MODIFICATION No. 23554P3127

TITLE : AIR CONDITIONING - COCKPIT - INTRODUCE PROTECTION AGAINST WATER CONDENSATION.

SERVICE BULLETIN No. : A320-21-1072

Installation of the Insulation Blankets on the Visible Structures
Figure 8, Sheet 4

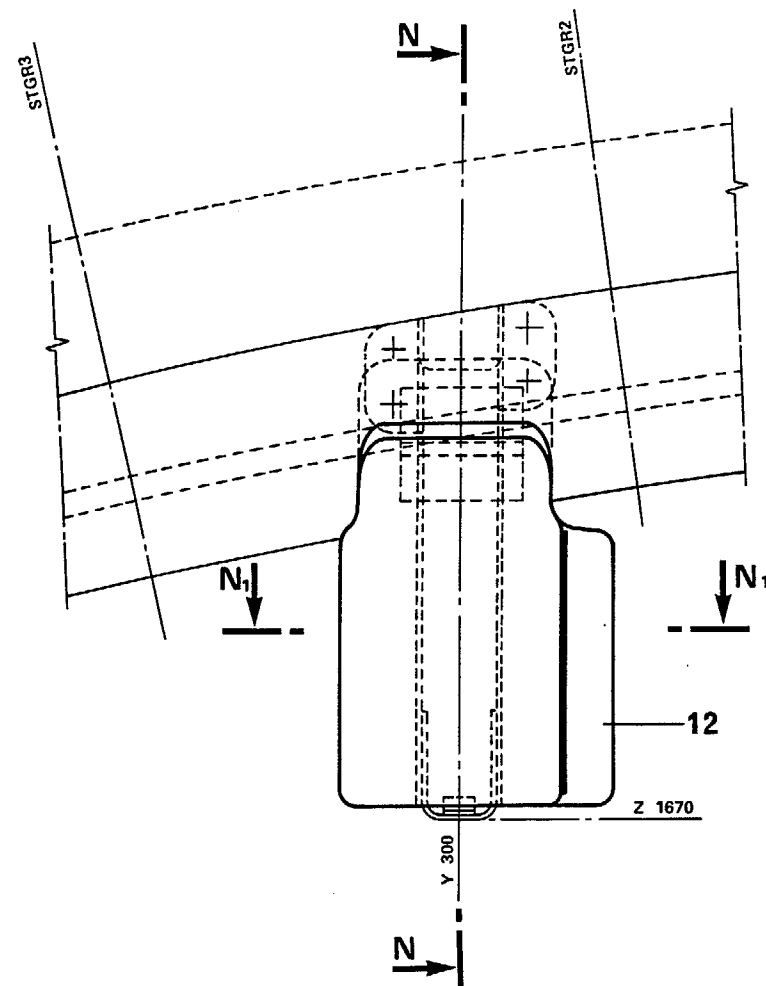
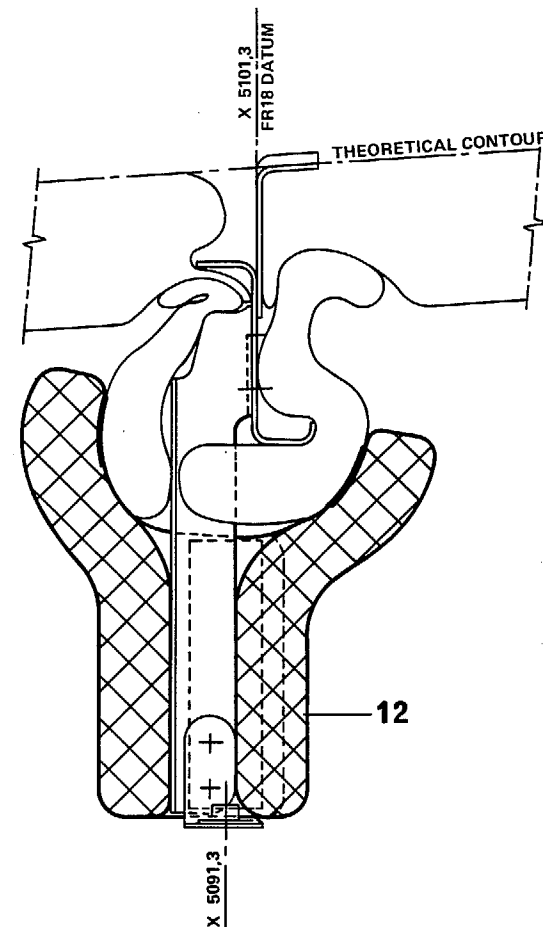
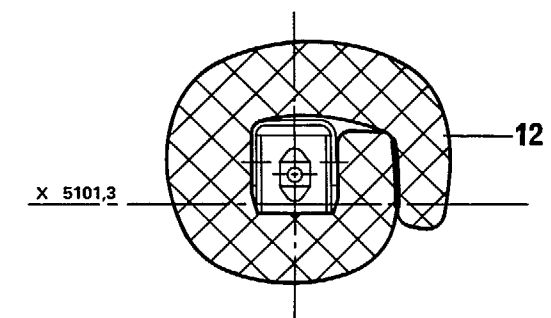
- (c) On the ceiling panel pick-up bracket, at FR16, install :

1 insulation blanket	D2581053700000	Item 10
1 insulation blanket	D2581053800000	Item 11

Installation of the Insulation Blankets on the Visible Structures
Figure 8, Sheet 5

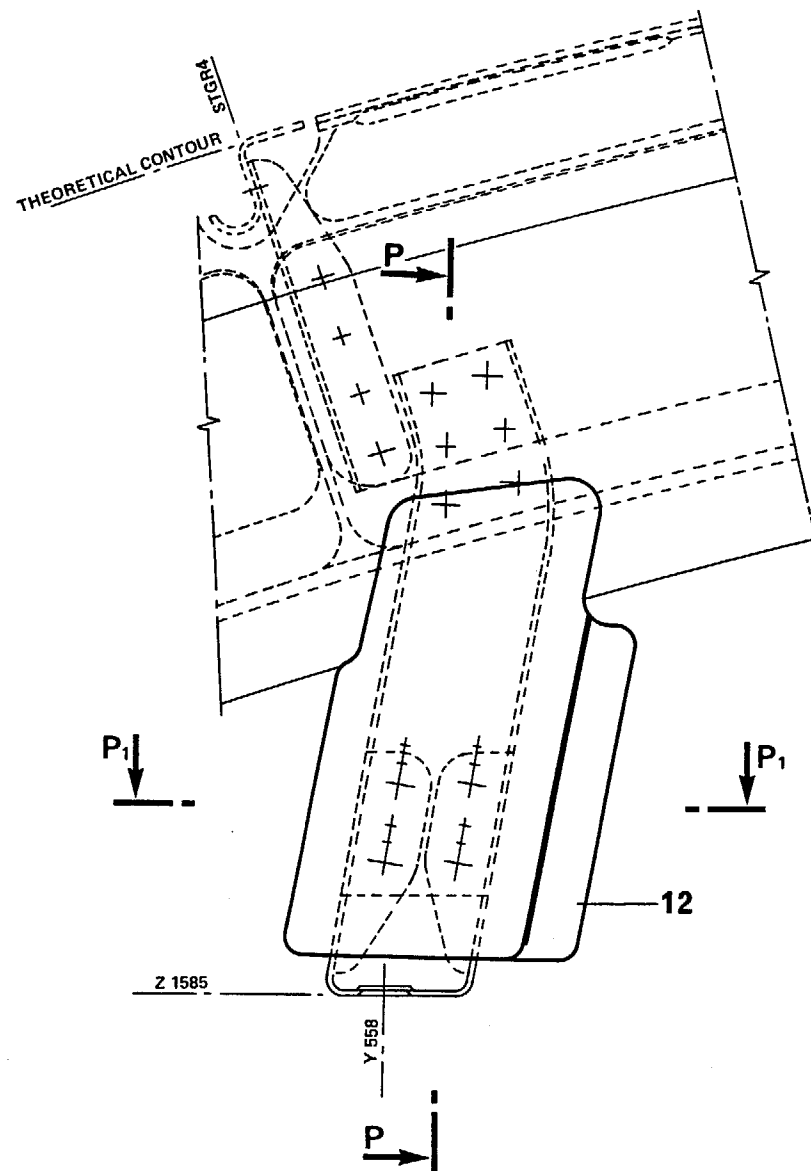
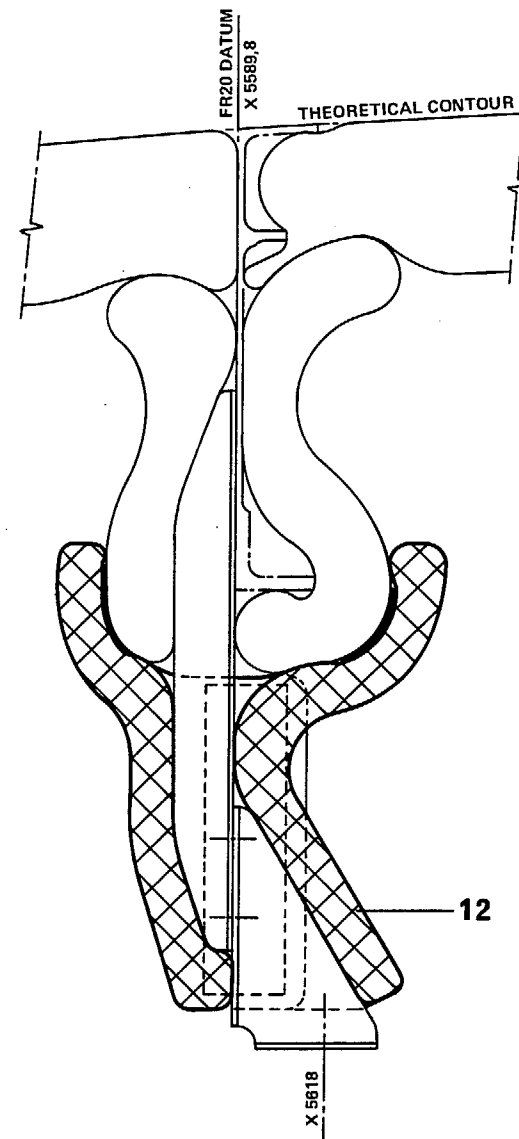
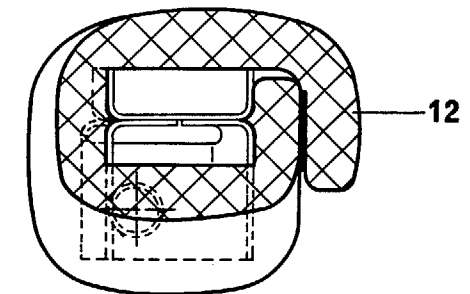
- (d) On the ceiling panel pick-up bracket, at FR18, install :

1 + 1 insulation blanket	D2581053900000	Item 12
-----------------------------	----------------	---------

Installation of the Insulation Blankets on the Visible Structures
Figure 8, Sheet 6

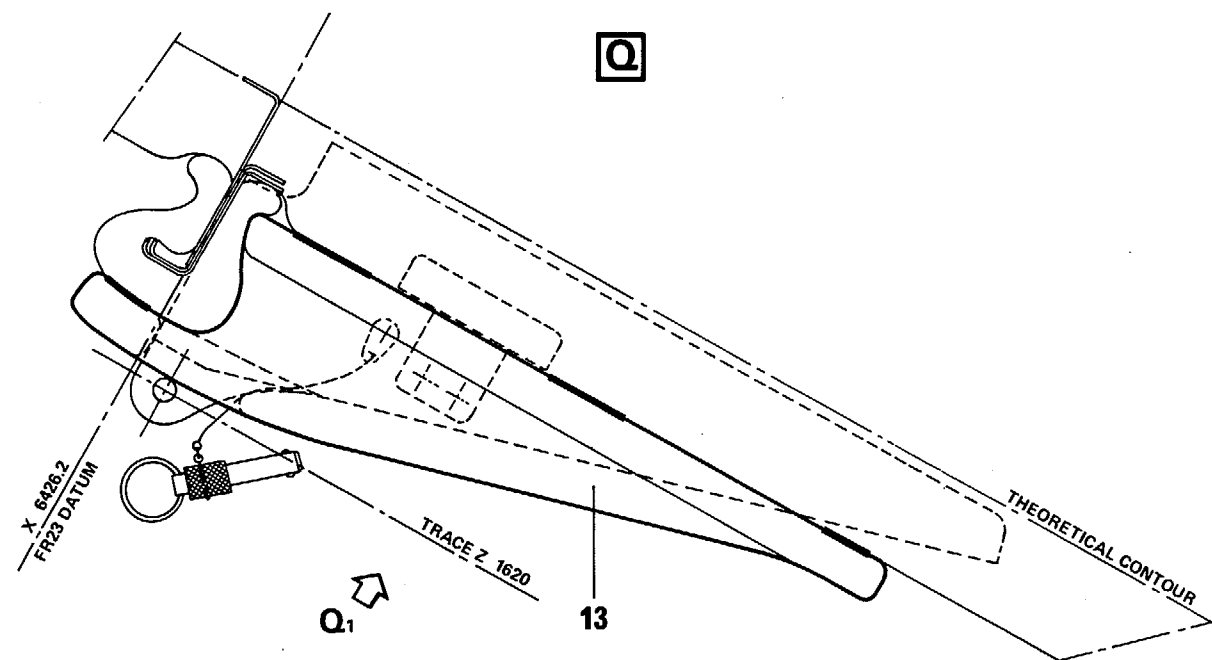
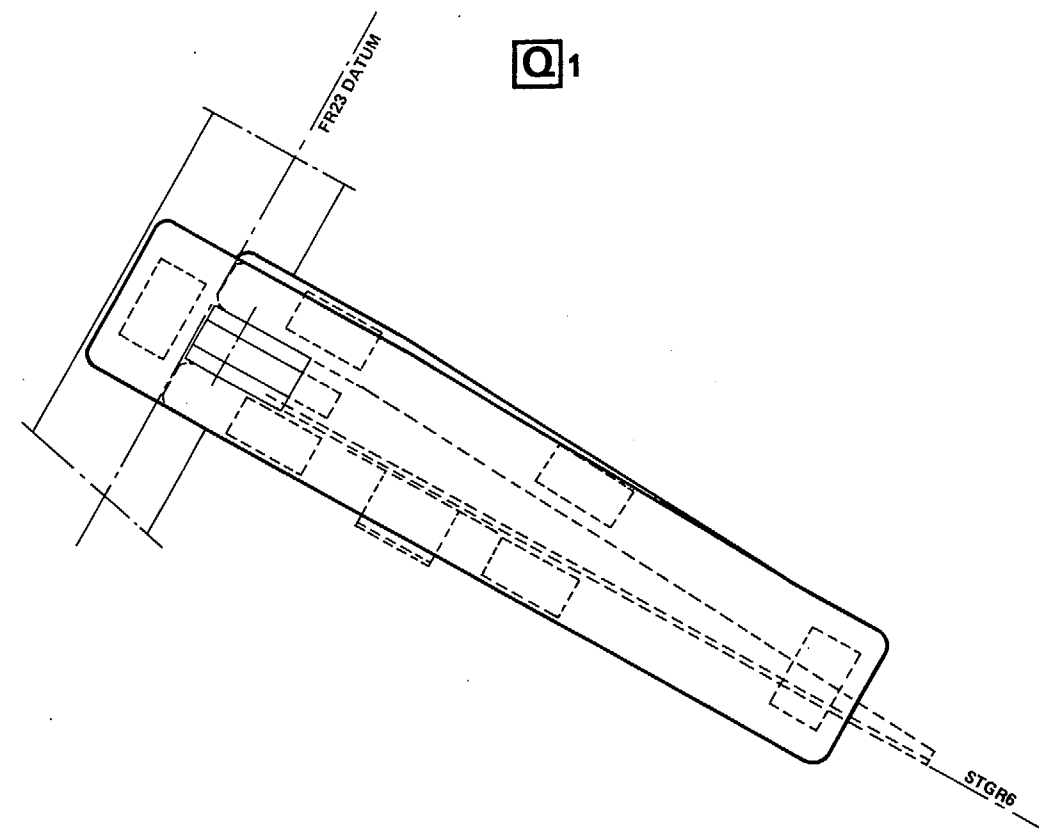
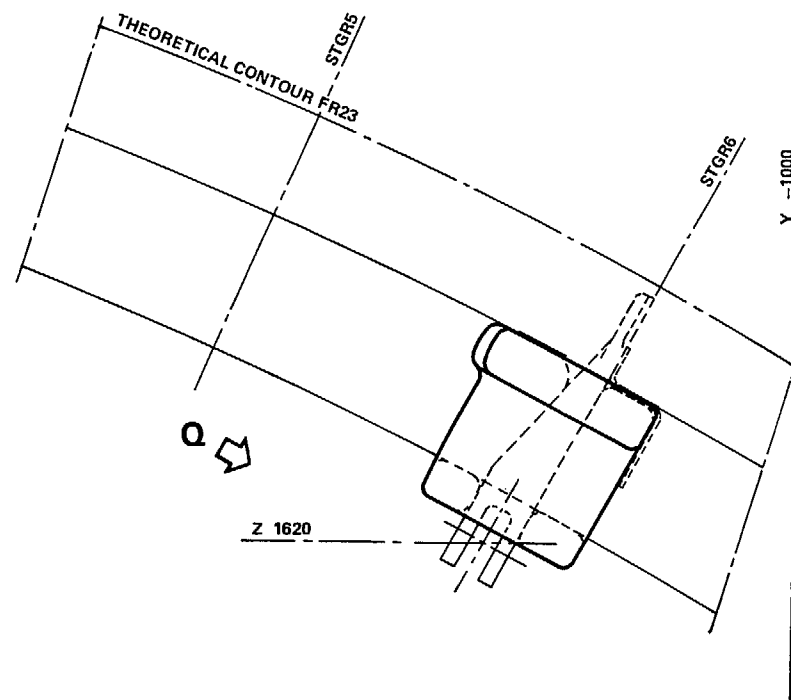
- (e) On the ceiling panel pick-up bracket, at FR20, install :

1 insulation blanket	D2581053900000	Item 12
----------------------	----------------	---------

Installation of the Insulation Blankets on the Visible Structures
Figure 8, Sheet 7

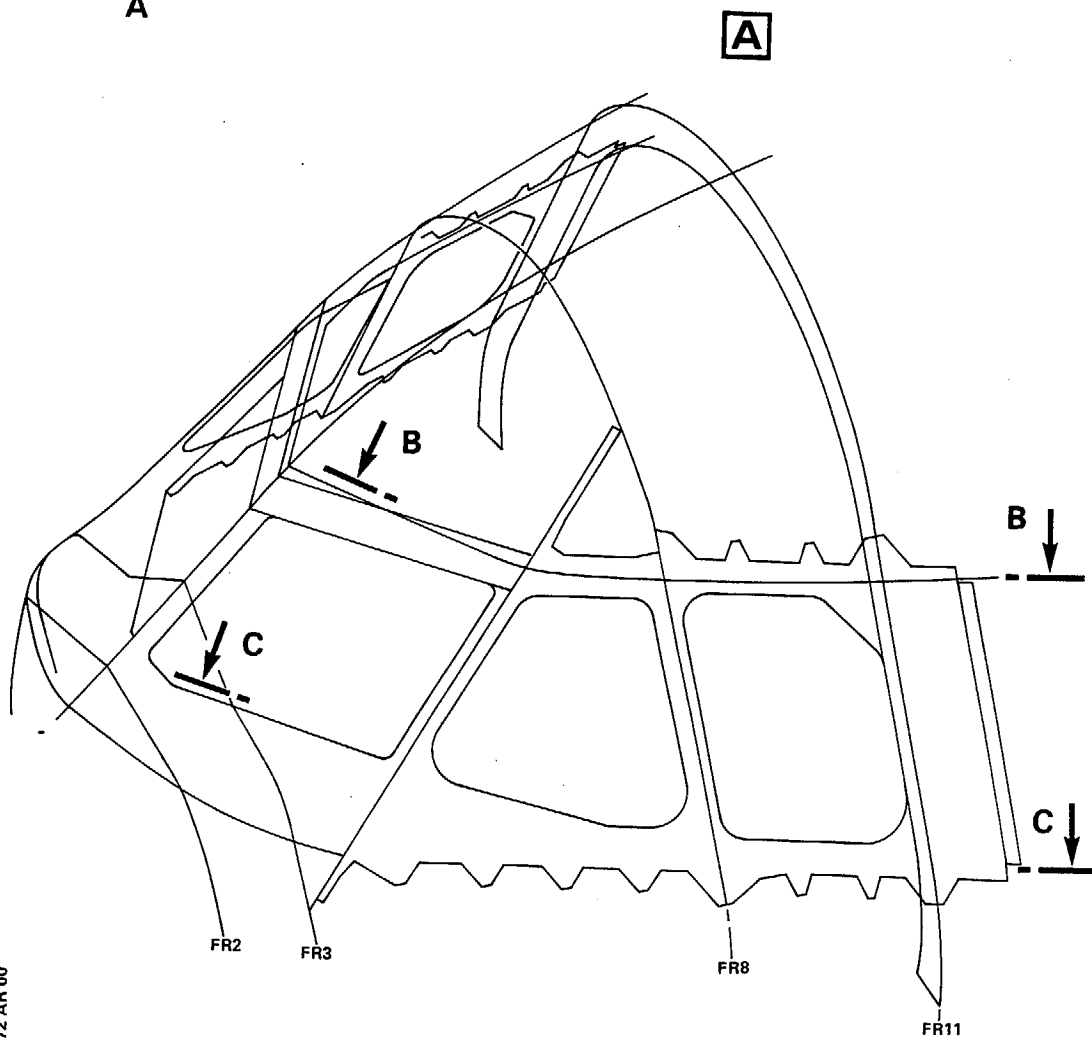
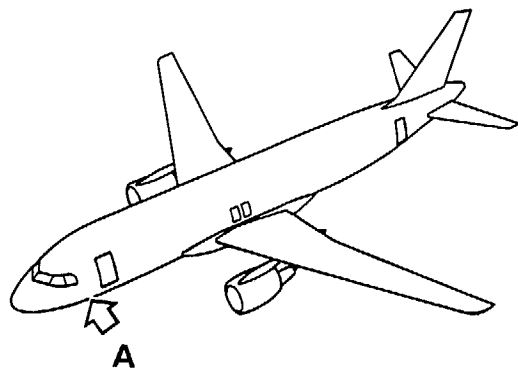
- (f) On the fitting at stringer 6 between FR23, FR24, R side, install :

1 insulation blanket	D2581054000000	Item 13
----------------------	----------------	---------

Blanking of Structural Holes at the Lower and upper
L and R Windshield front Sections
Figure 9, Sheet 1 of 3

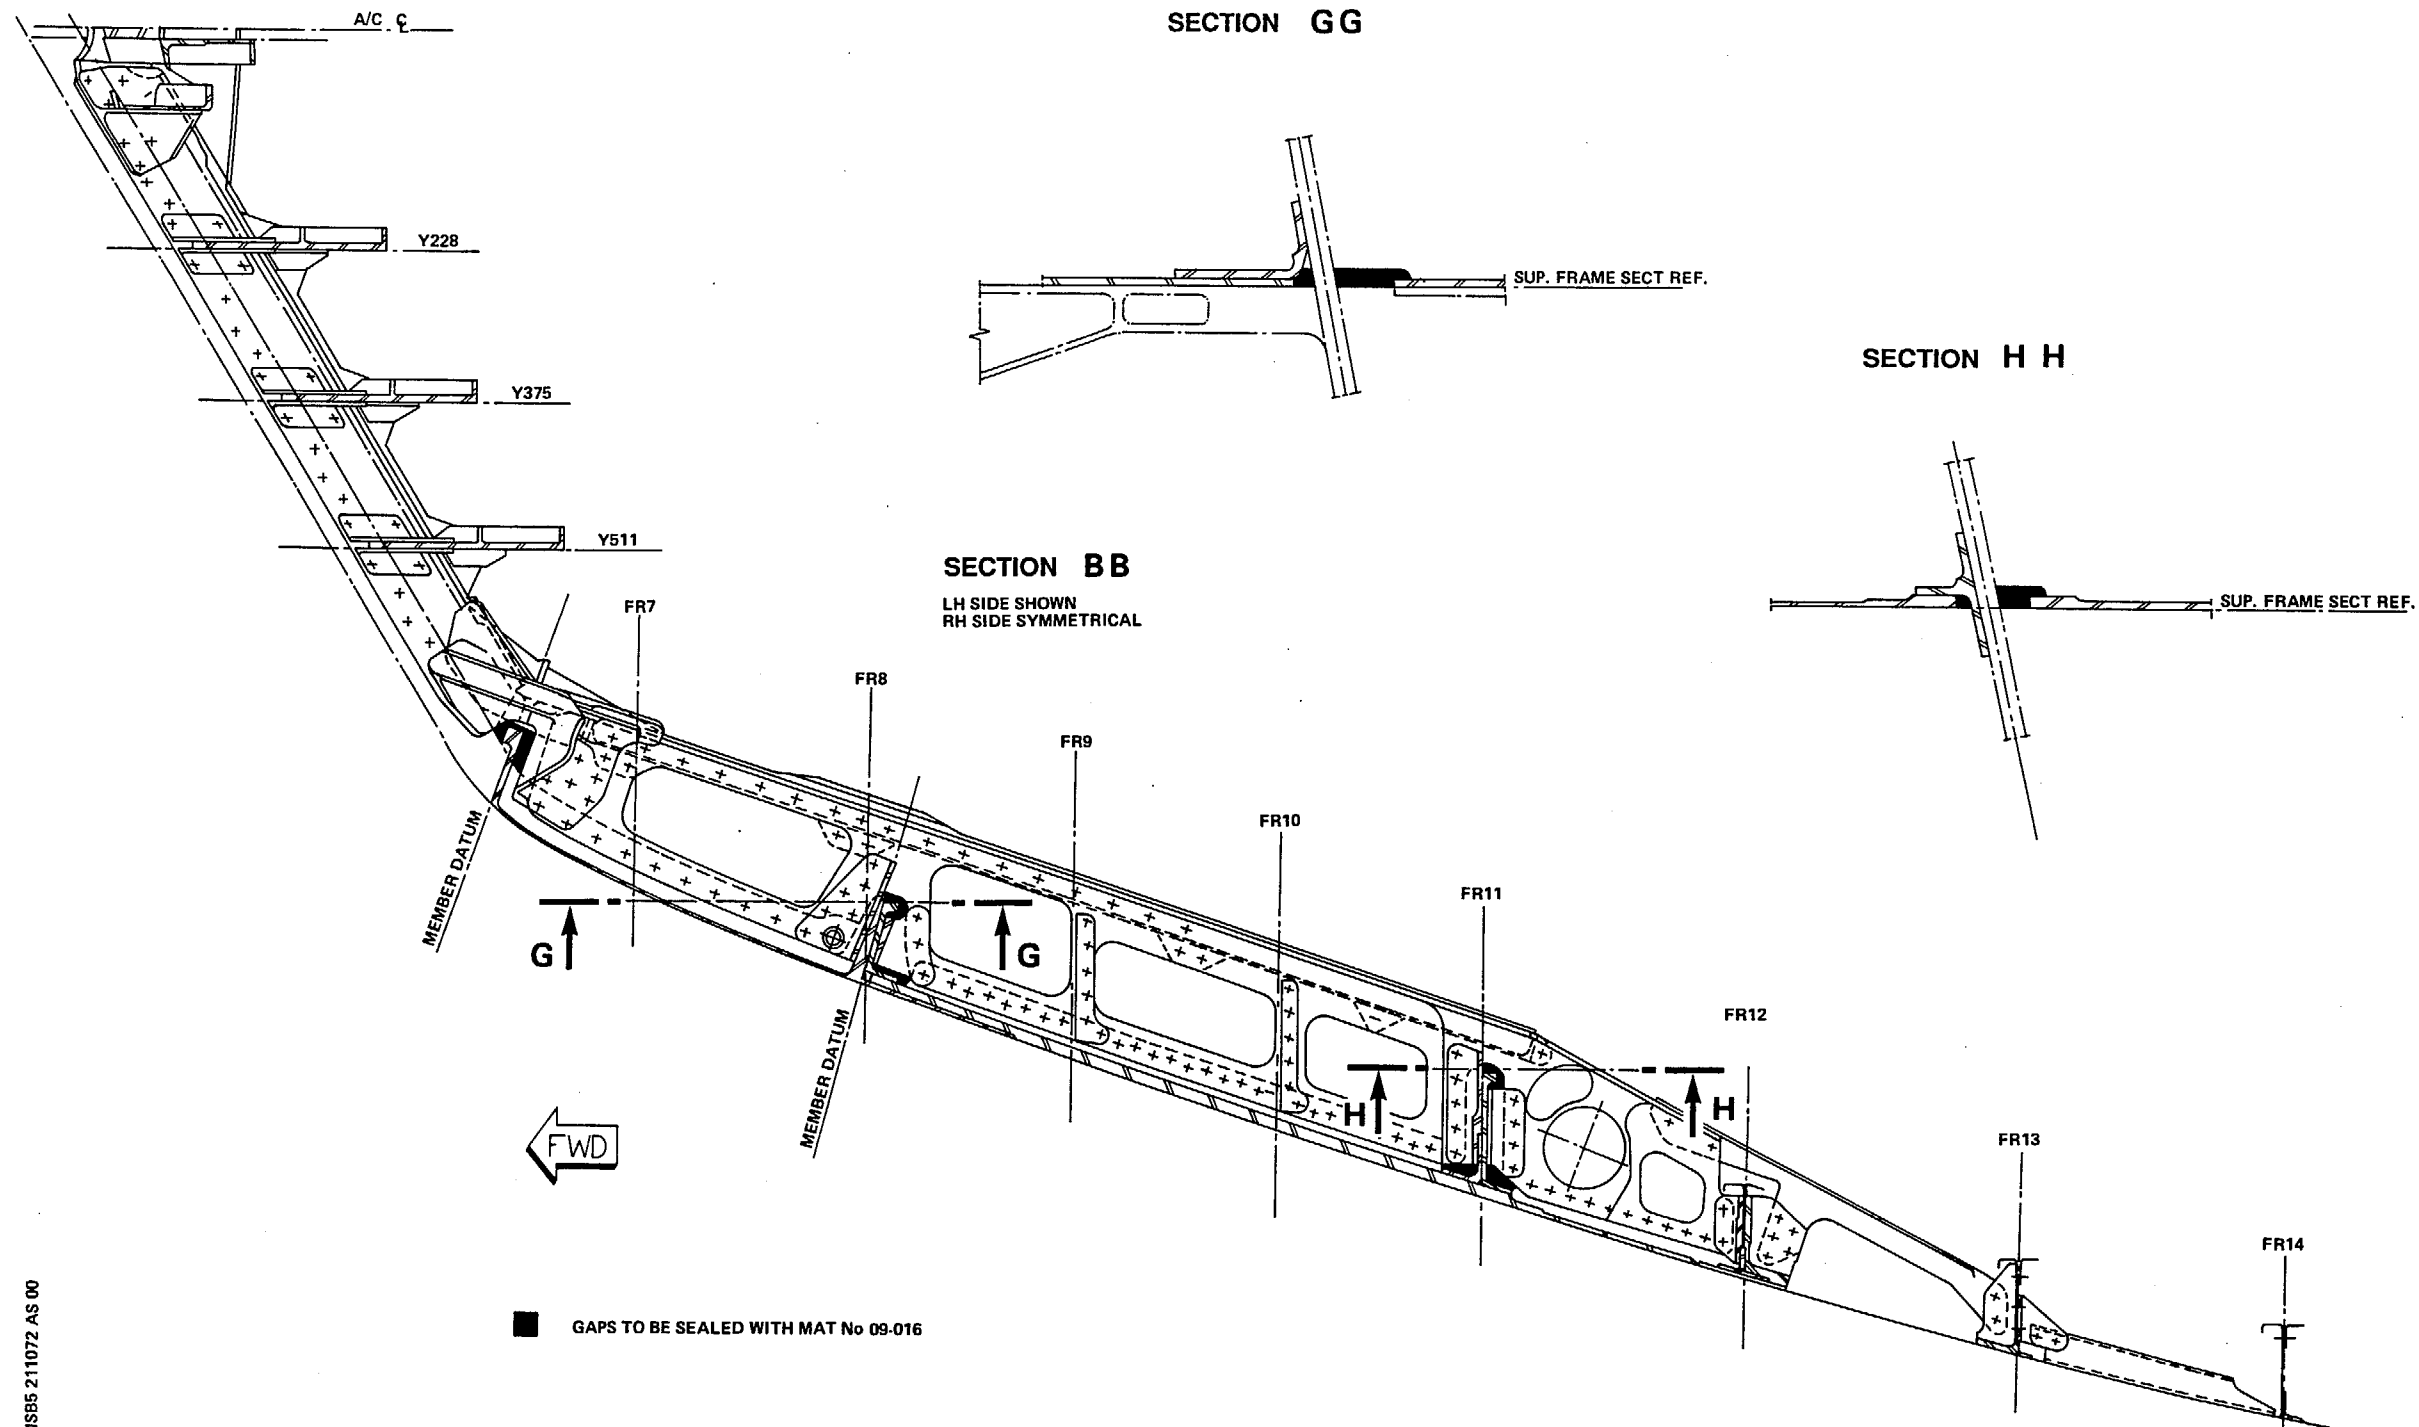
- (9) Installation of sealant on the structural holes at the lower and upper L and R windshield front sections

At the frames 8 and 11 intersection holes, install sealant Mat. No. 09-016.
